July 2, 2015
	Alberta Technology Center
Owner:	The City of Tuscaloosa
Owner's Project No:	A15-0513
Architect:	Ward Scott Architecture, Inc.

Addendum No. 3 - Structural Items

1 OVERALL SITE PLAN
1" = 10'-0"

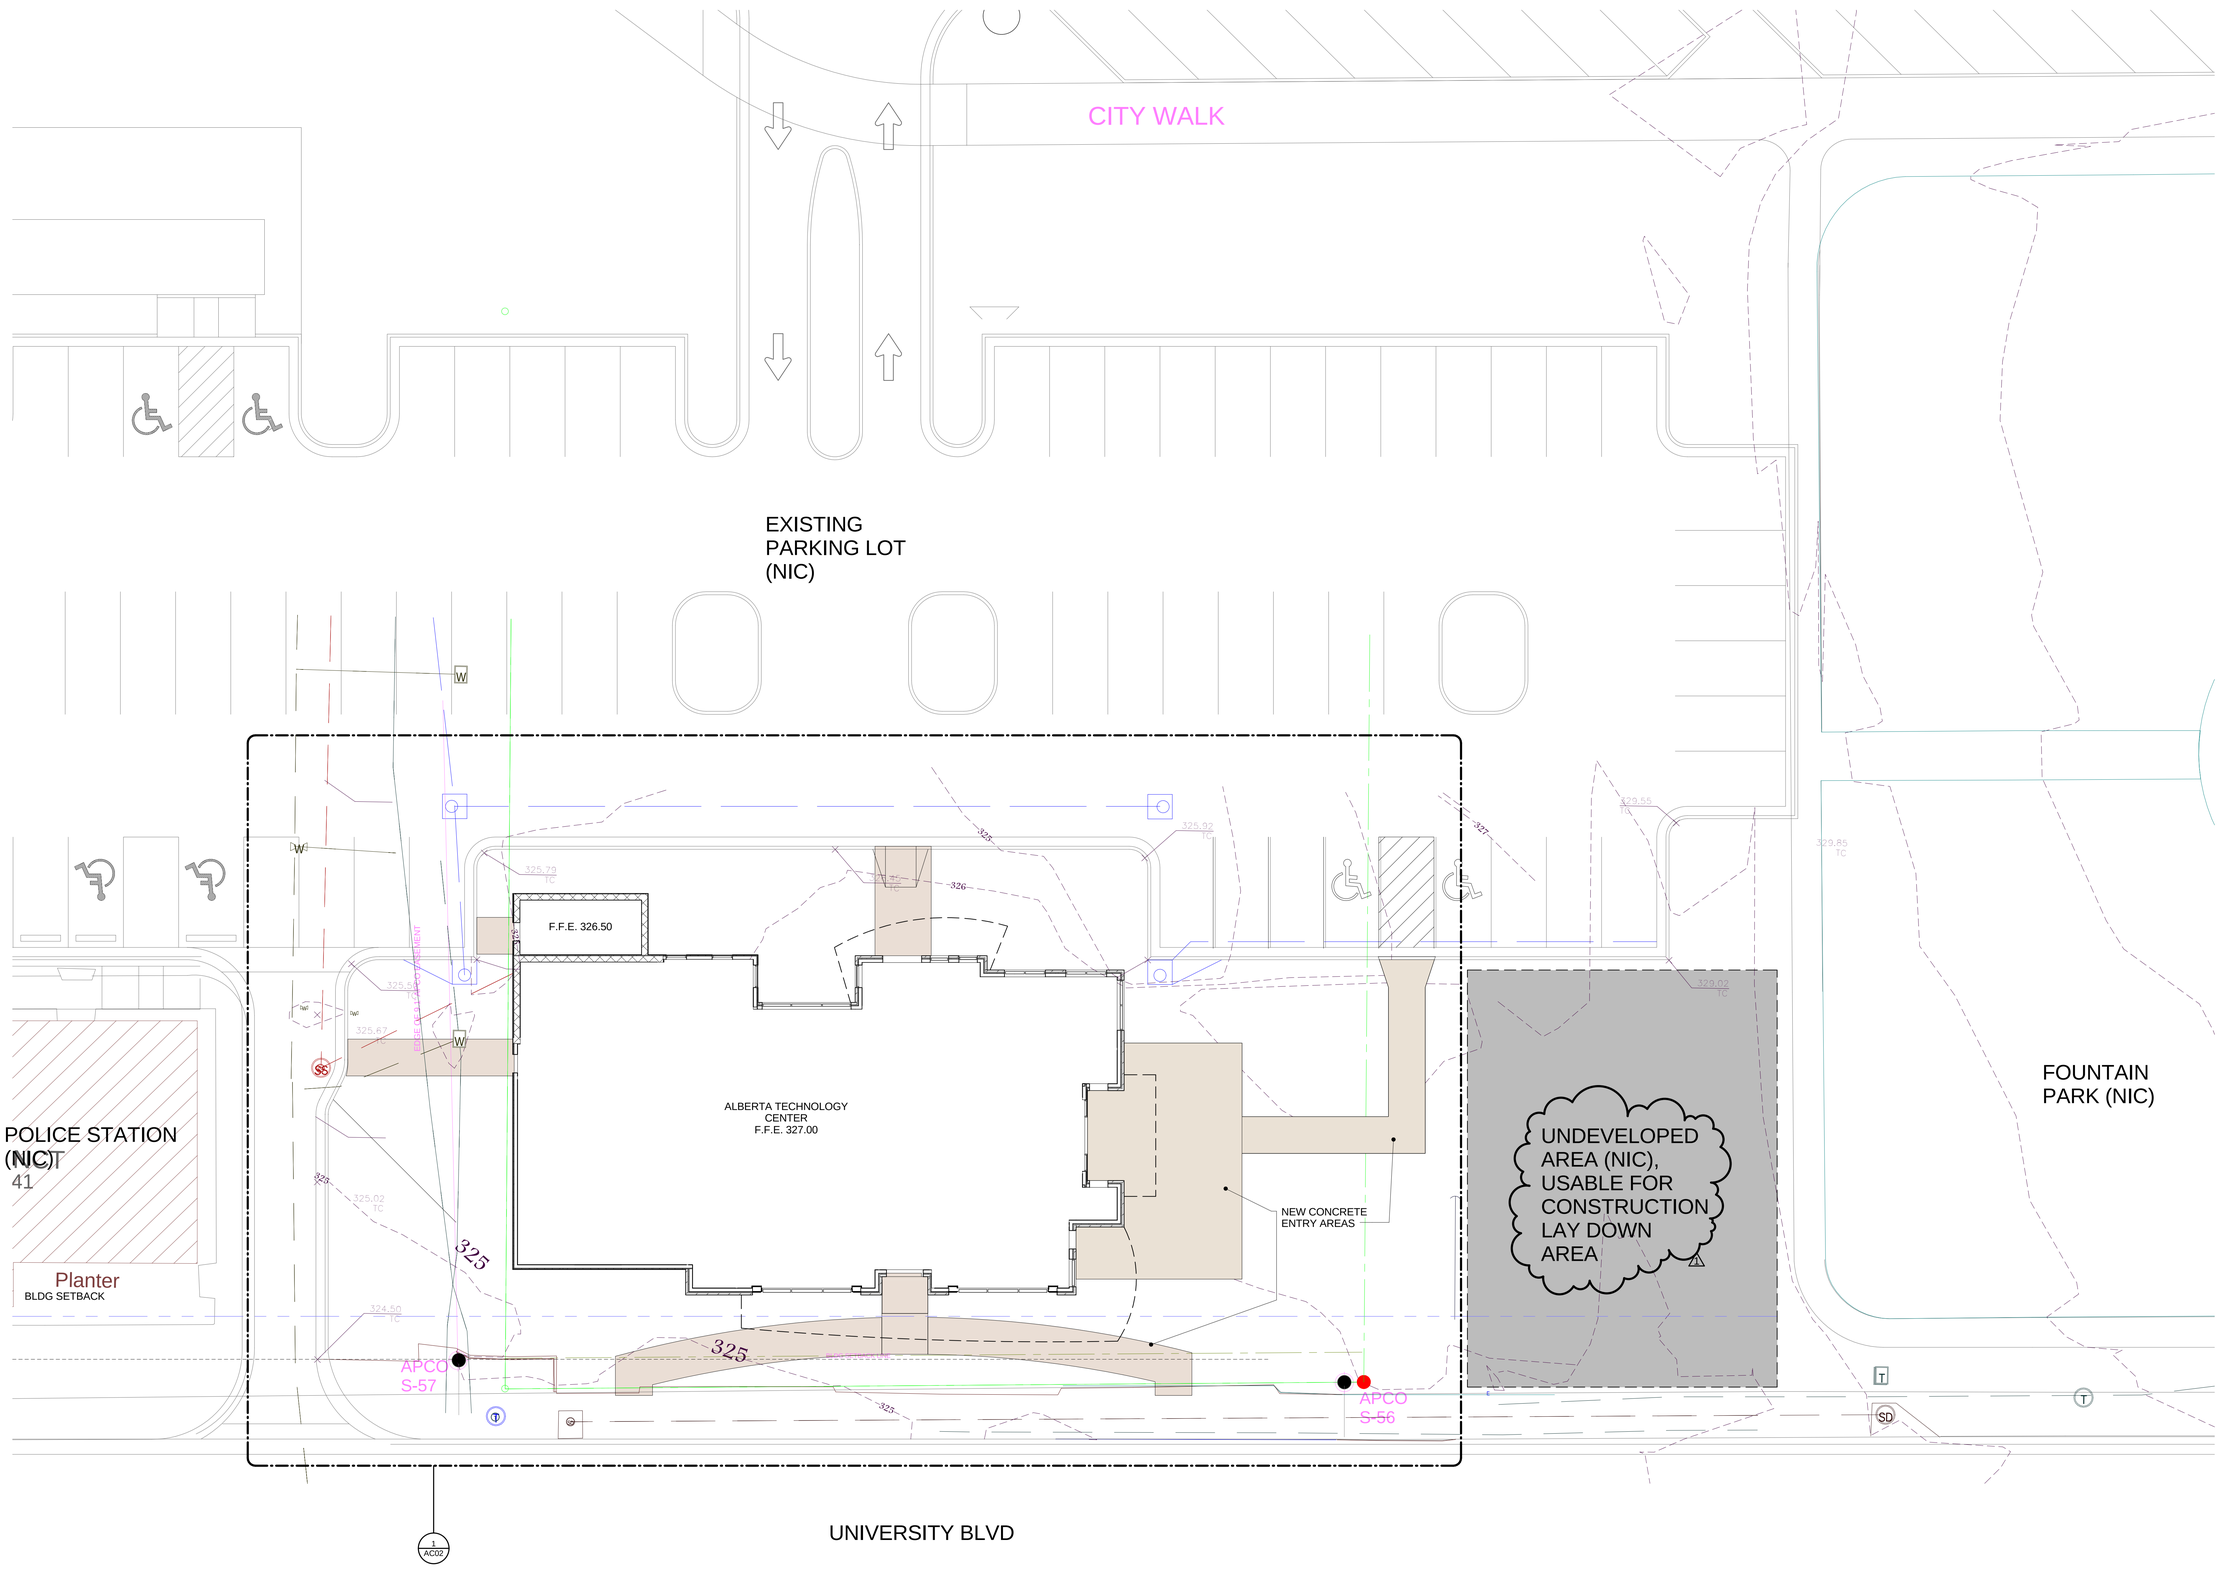
2. AC01 Overall Site Plan. Note west sidewalk has been adjusted north to work with door exit. East side of site (not in contract) will be used for Contractor lay down space in this project.

4 STOREFRONT WINDOW FRAMES
1/4" = 1'-0"

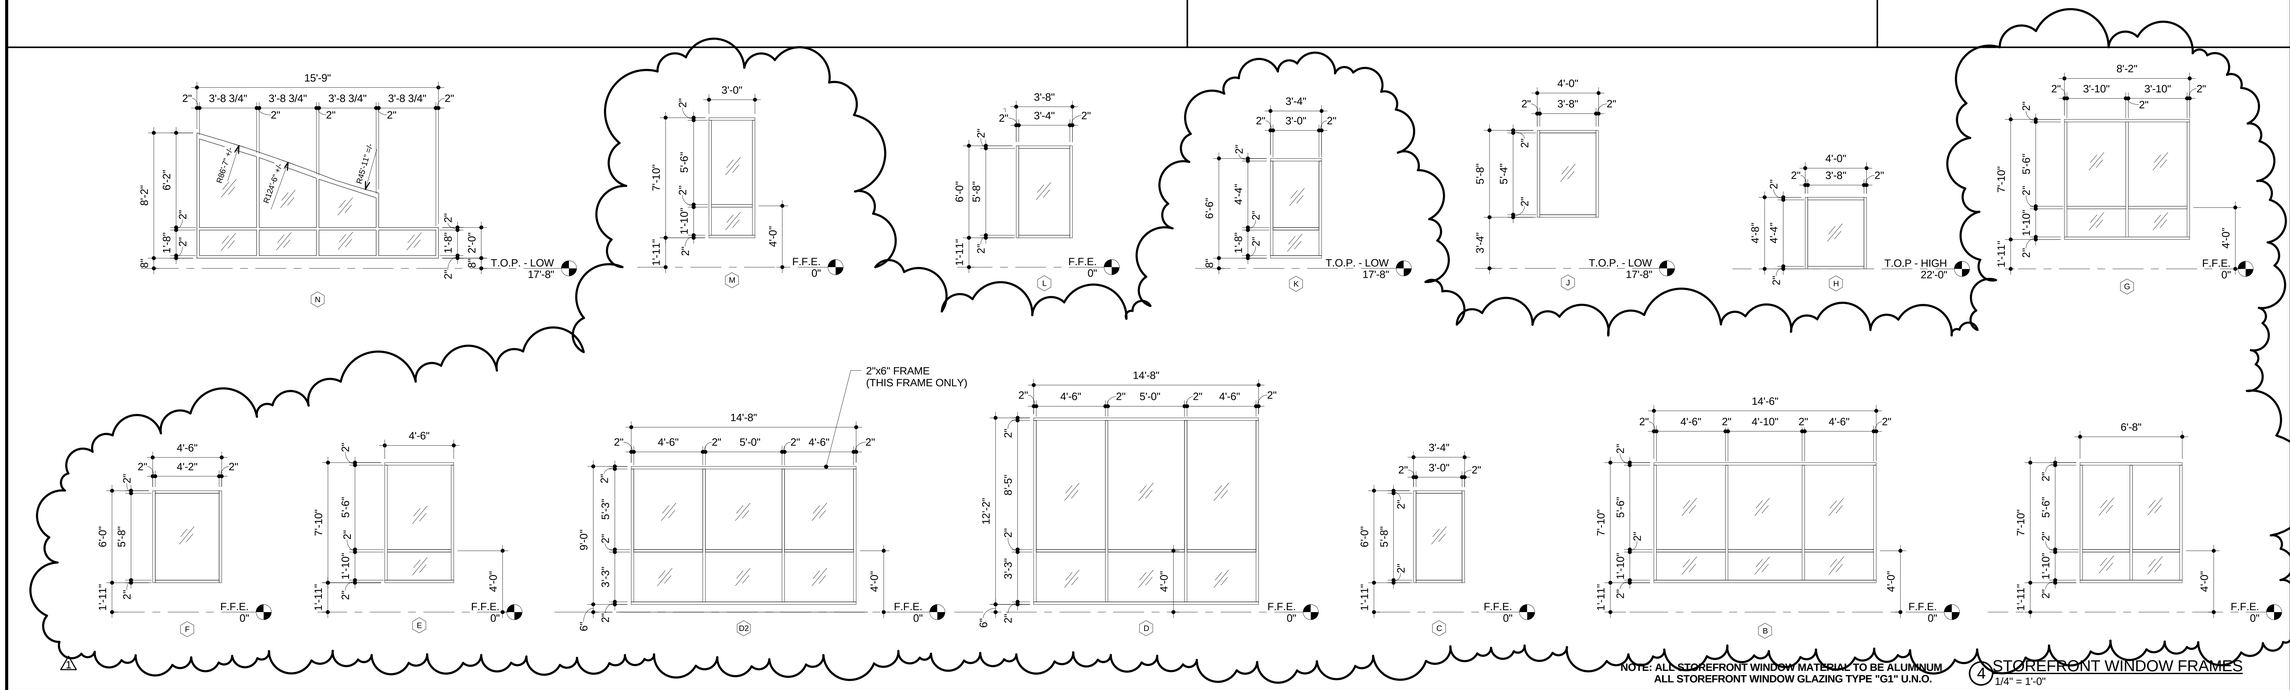
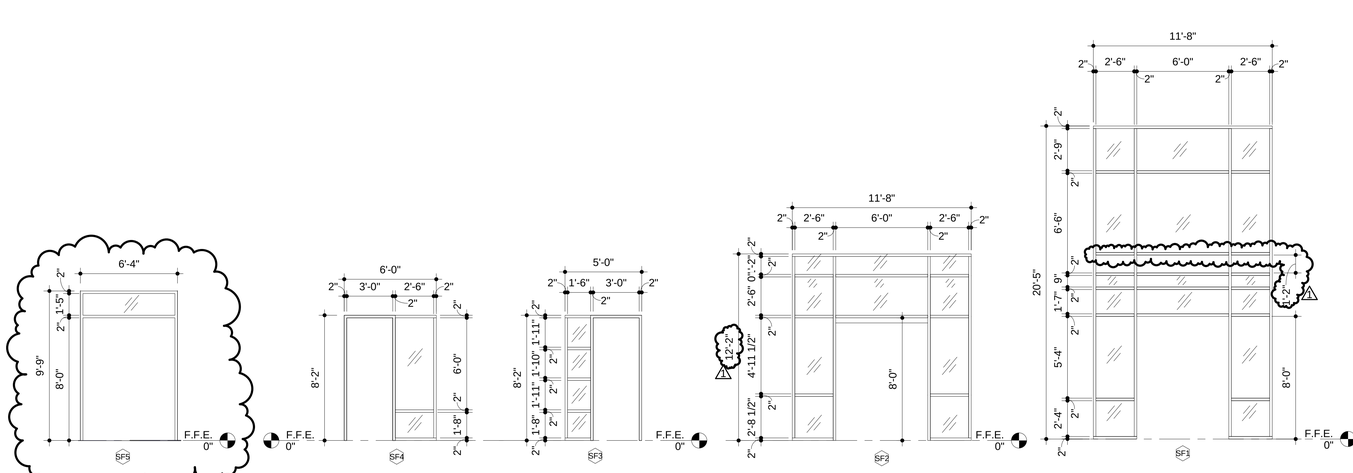
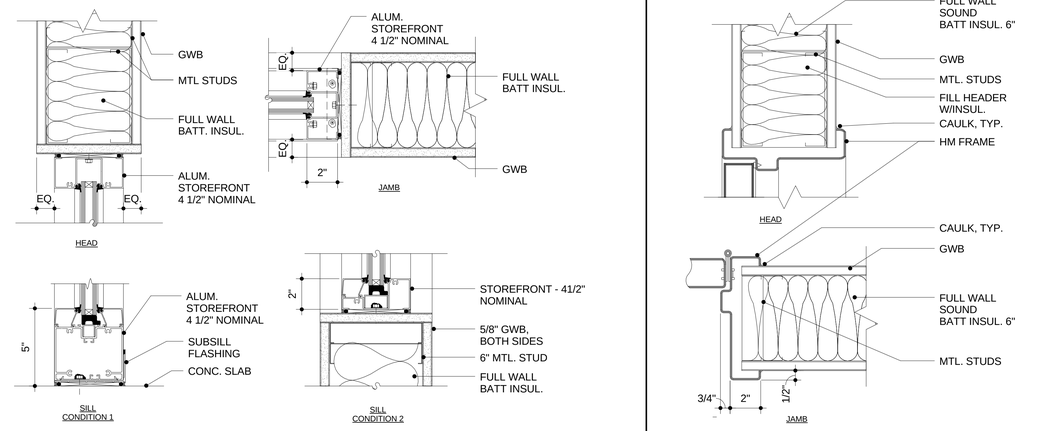
4. A002 Opening Schedules and Details.
      a. SF1 to have additional horizontal mullion.
      b. SF2 overall height reduced by 4".
      c. SF5 added to include transom over pair of doors.

d. Storefront frames have been adjusted to "engineer" brick coursing. Horizontal mullions and cast stone headers have been included at standard heights for typical window assembly in masonry walls.

1 DIMENSION PLAN
1/4" = 1'-0"

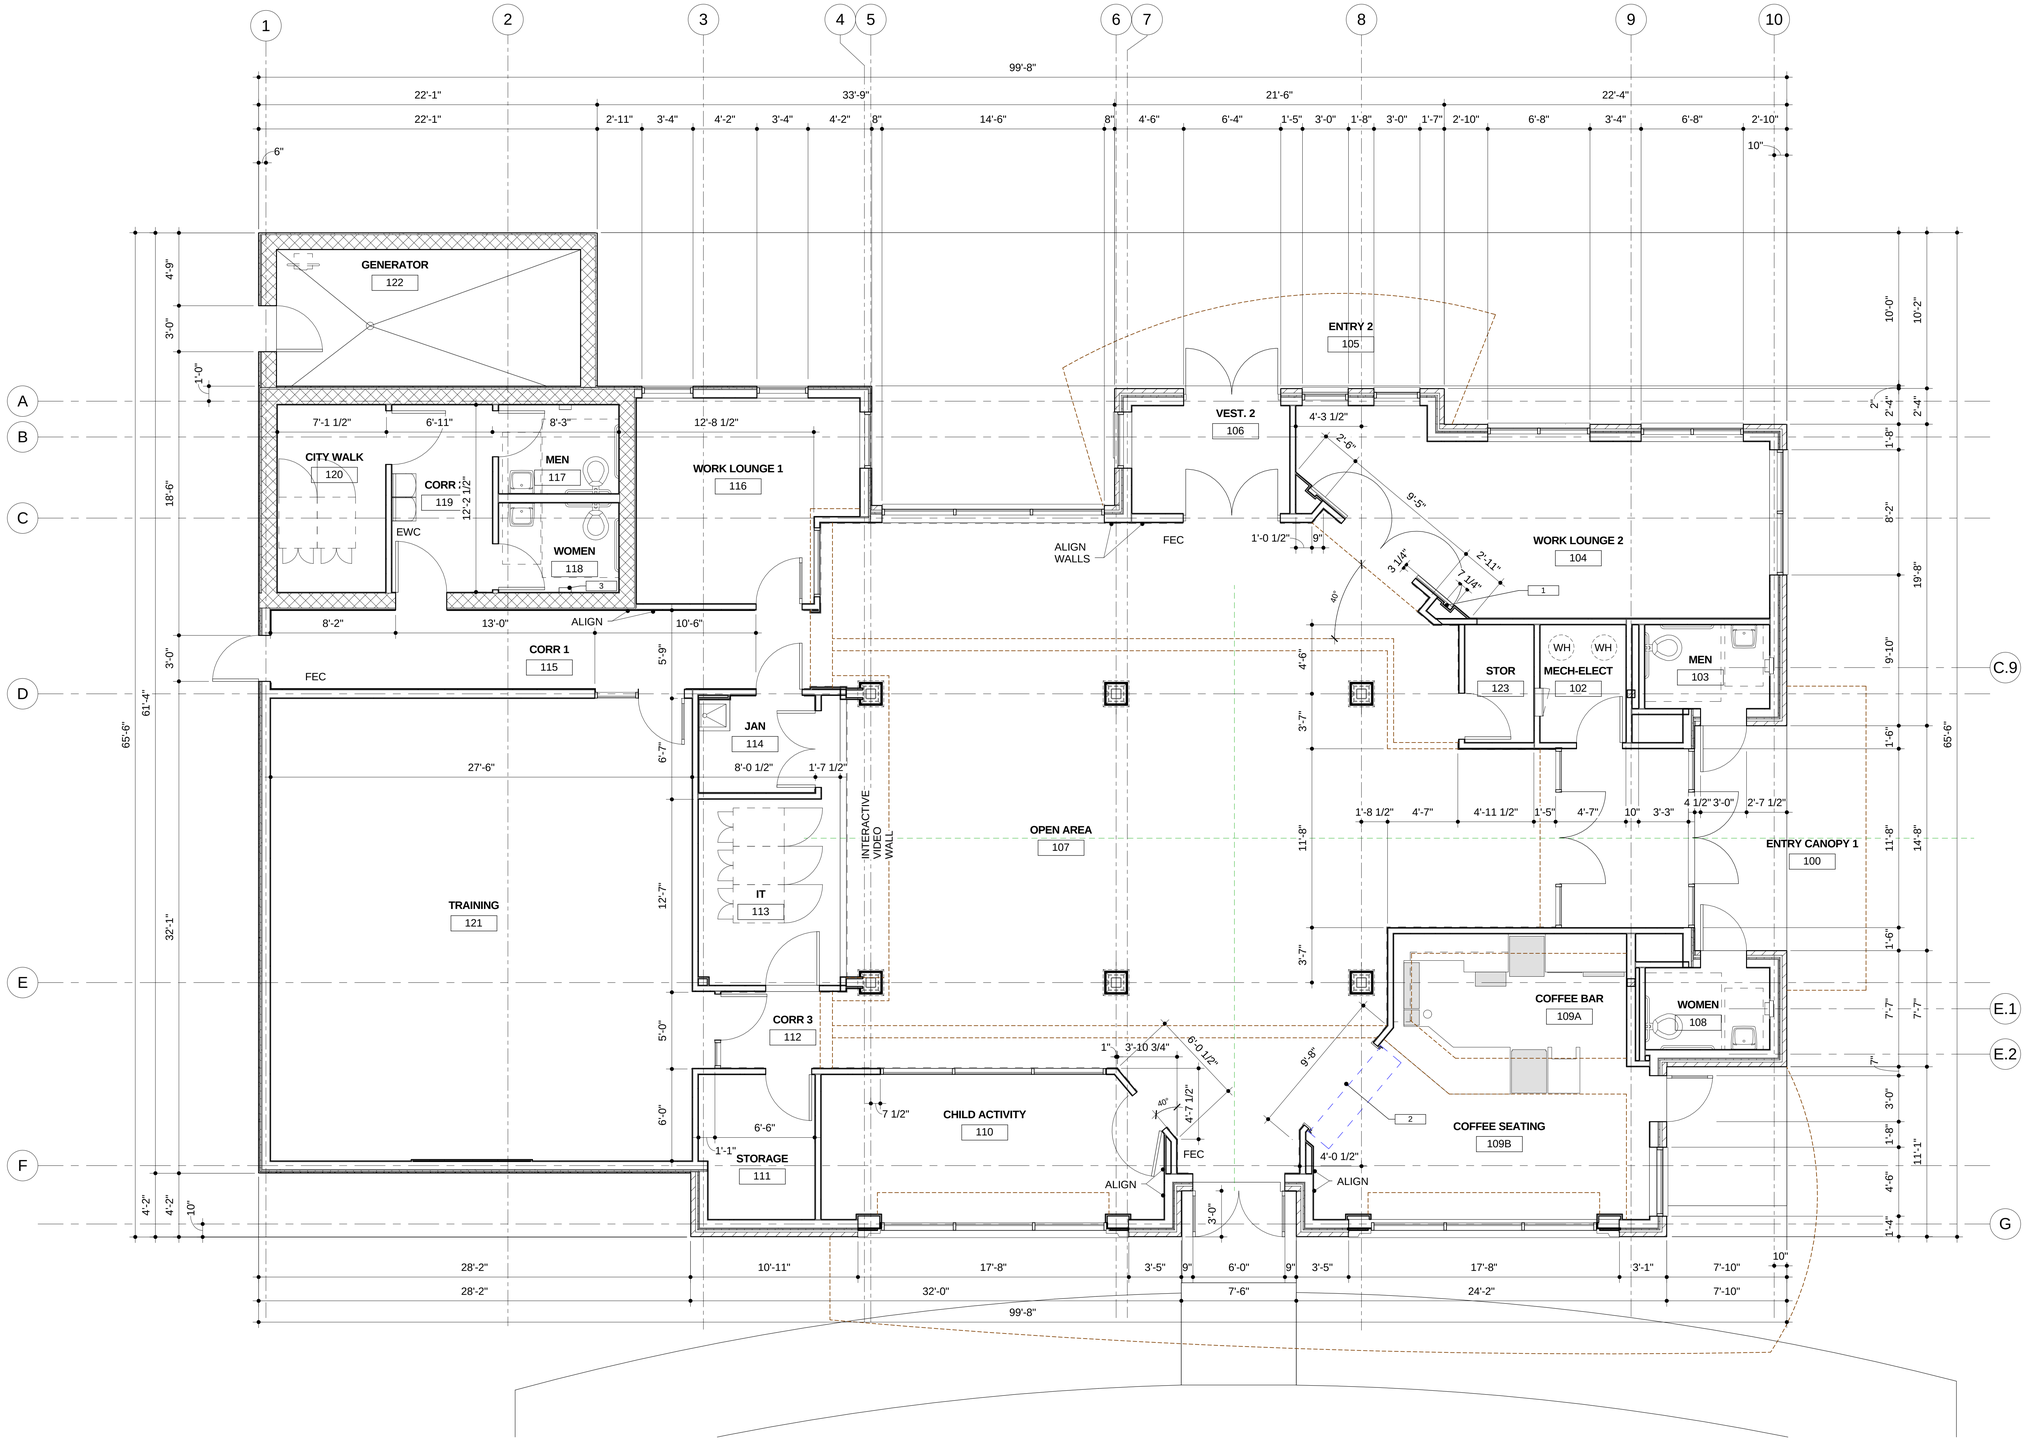
e. Door 123A – Hardware Set changed to 8A.
   5. A102 Dimension Plan – east exterior wall at exit doors has moved east 7" toward coffee bar. Interior wall adjustments are reflected. All exterior dimensions have been updated to reduce fractions.

3 DETAIL - EAST CANOPY
1 1/2" = 1'-0"

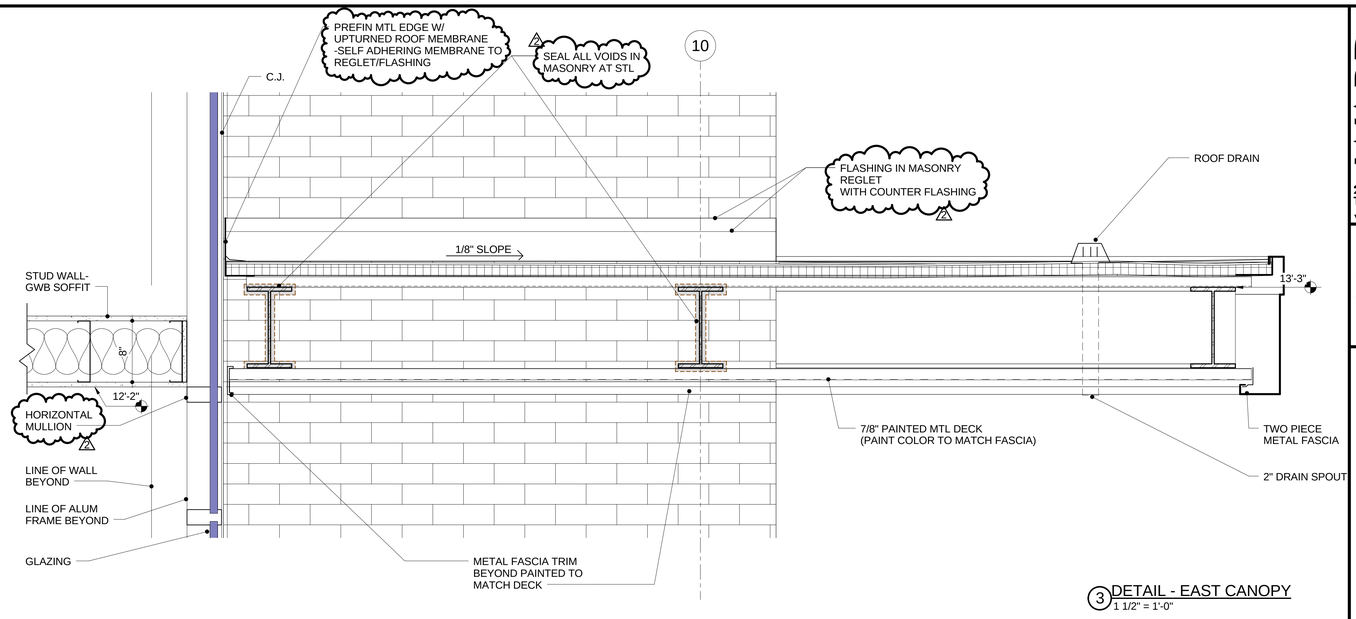
6. A105 Canopy Plan. Detail 3. Additional horizontal mullion shown in SF1. Height of Gyp soffit reduced by 4". Roofing/reglet flashing info has been added.

2 ENLARGED WOMENS
1/2" = 1'-0"

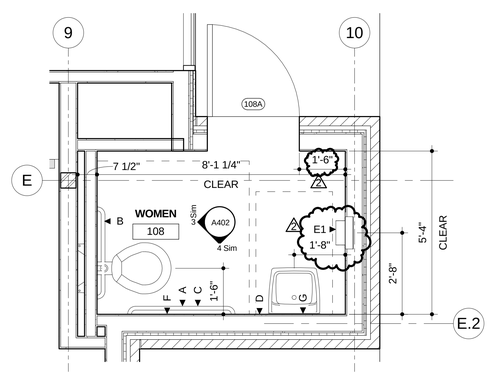
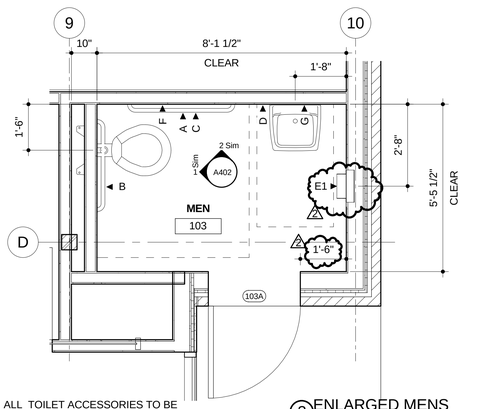
7. A111 Enlarged Floor Plans. Detail 2 and 3. Note Accessory E1 has been added showing recessed fixture, whereas E fixture is not recessed. Note dimensions at Doors 103A and 108A have been added for clarity. Note updated dimension (EQ) at Men 117 and Women 118.
